**PORT OF ALASKA MODERNIZATION PROGRAM
DESIGN/BUILD SERVICES FOR
HELIPAD AND ACCESS ROAD**

REQUEST FOR PROPOSAL NO. 2026P002

NAME: Port of Alaska Helipad and Access Road - 1st Plan Review

Preliminary Design
Helipad and Access Road
FIGURE 12

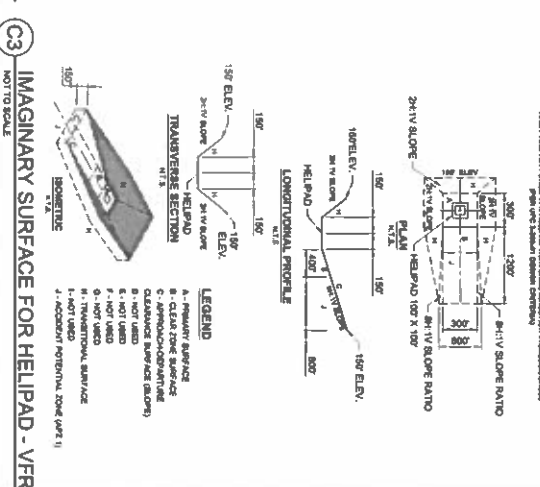
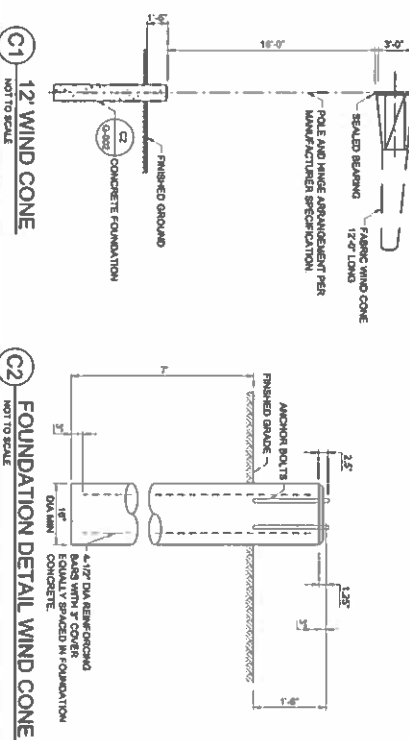
6	ROW	General	MSW	Provide existing and proposed finished grades.		
7	ROW	General	MSW	Show drainage patterns.		
8	ROW	General	MSW	Provide culvert locations with inverts and outfall elevations		
9	ROW	Sheet 2	MSW	Clarify statement prior to paving scalping six inches to remove unsuitable organics and silty soils. With a road built to approved plans, I am not sure why organics would be present.		
10	PD	Sheets 4/5/6	PL	It was stated that profiles are not required, but consider including profiles under each plan view. Might save some headaches down the road.		
11	PD	Sheet 2	PL	Typical Sections - these are pretty thin sections (unless the subgrade is good, non frost susceptible soils). Acquiring/including geotechnical information is recommended.		
12	PD	Sheet 2	PL	You might consider placing geotextile fabric under the Type IIA (depending on the underlying soils).		
13	PD	Sheets 4/5/6	PL	If geotechnical data is available, provide boring information and location on plan/profile sheets.
